# **RESPONSE TO THE TECHNICAL MEMORANDUM ON BICYCLE AND PEDESTRIAN FACILITIES ASSESSMENT**

On May 28, 2015, The City of Los Angeles, Bureau of Engineering, submitted a Technical Memorandum (TM) by Psomas, regarding bicycle and pedestrian facilities on the Glendale Boulevard-Hyperion Avenue Complex of Bridges. It included an inventory of facilities, a comparison of existing and proposed conditions, and most significantly, an evaluation of significant thresholds for bicycle and pedestrian safety based on the Los Angeles CEQA Thresholds Guide (2006) and recommendations to enhance bike and pedestrian travel and safety.

Figure 4 Comparison of Existing and Proposed Pedestrian Facilities

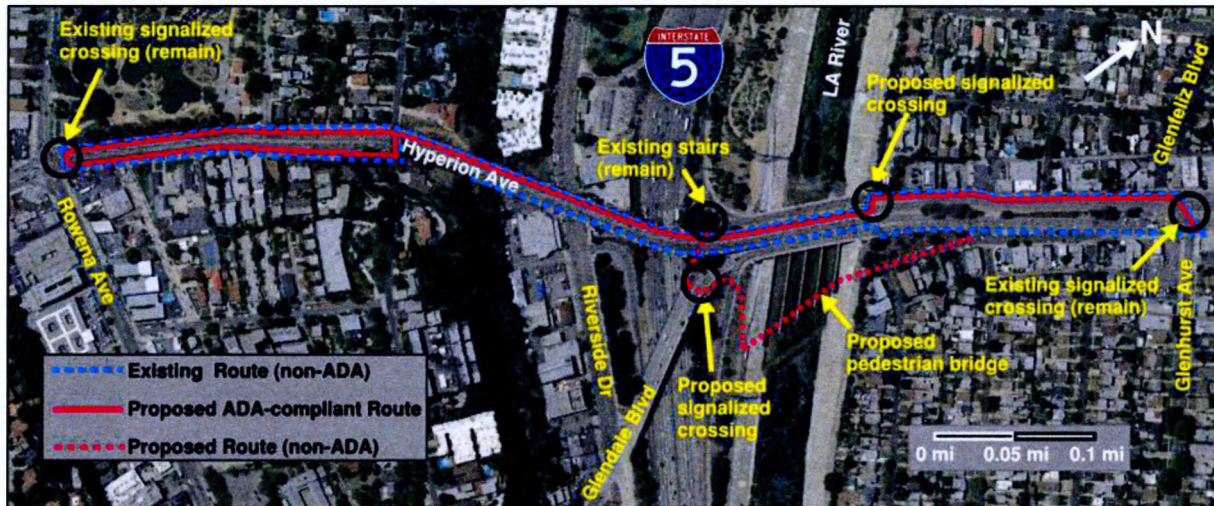
1. While the new six-foot sidewalk along the west side of Hyperion Ave over I-5 and the Los Angeles River provides ADA compliant PAR on one side of the bridge, it fails to provide a PAR for pedestrian on the opposite of the bridge thereby adding a ½ mile of pedestrian travel distance.

2. While the new pedestrian bridge to be constructed across the Los Angeles River on the Old Red Car piers east of the Hyperion Bridge provides much needed access to the bike path from the Atwater side of the bridge, it fails to provide a compliant PAR for pedestrian travel from Atwater to Silver Lake and Los Feliz.

3. Longer travel paths for pedestrians starting or ending their trips on the east-side of Glendale Blvd between the Los Angeles River and Glenhurst Ave exist. The disadvantages listed in the TM incorrectly minimize the estimates of travel times for both able-bodied and disabled pedestrians. It fails to recognize that much of the pedestrian activity will be on a significant grade. Assuming the travel distances are correctly indicated in the TM, the significant travel time impacts on pedestrians are more correctly reflected as shown.

- Able-bodied: Longer travel time of 2.6 minutes at 2 ft/s walking speed for 310 ft distance.
  - Disabled: Longer travel time of 17.2 minutes at 1.5 ft/s for 1550 ft distance. This travel time can be compounded due to the 5 percent grade in the Atwater to Silver Lake travel path.

Figure 5 Area Potentially Impacted by Lack of Sidewalk on East Side of the Hyperion Bridge

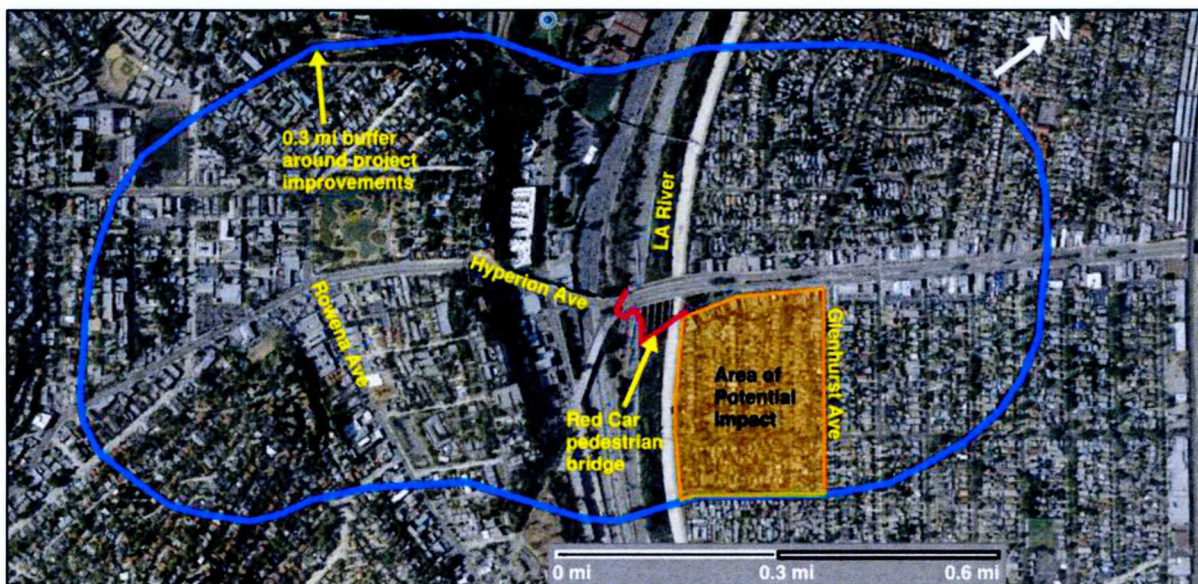
The disadvantages in the TM's recommended improvements are based on incorrect assumptions and miscalculations. By having a sidewalk on only one side of the road, there is a significant safety risk of conflicts between bicyclists and pedestrians walking on the bike lane along the east side of Hyperion Avenue between Waverly and Glenfeliz/Glenhurst .

1. The TM incorrectly assumes that pedestrian volume percentages will remain equally split (75% vs. 25% ) between the sides of the bridge when a new bike lanes are added on both sides of the bridge with only one sidewalk on the west side. Like water, pedestrians often find the path of least resistance and if the bike lane provides an opportunity for the easier flow for walkers, a higher percentage of pedestrians could utilize the east side bike lane. The current percentage split exists because the west side substandard sidewalk is still measurably wider and safer than the substandard east side sidewalk.

2. The TM indicates that 19% of pedestrians are disabled nationally and will be unable to negotiate the stair access to the Red car bridge, and may walk in the bike lane. This is a high risk factor that the TM minimizes, and fails to recognize the risk factors are compounded with bicyclist coming down the 5 percent grade at speeds that can easily exceed 20 mph, and conflicts with slow to respond disabled pedestrians.

3. The TM incorrectly calculates the pedestrians walking in the bike lane as less than one in the observation time of 12 hours. The pedestrian origin data collected from the impacted areas still fails to recognize that the 24 pedestrians counted in the data collection is biased data and has

not taken into account the other factors listed above. The conflict between even one pedestrian and a bicyclist can result in serious injury or death for both pedestrian and bicyclist. The conflict is not "minimal" as the TM suggests. To state the conflict is "minimal, the TM is making a subjective measurement of value of human life.
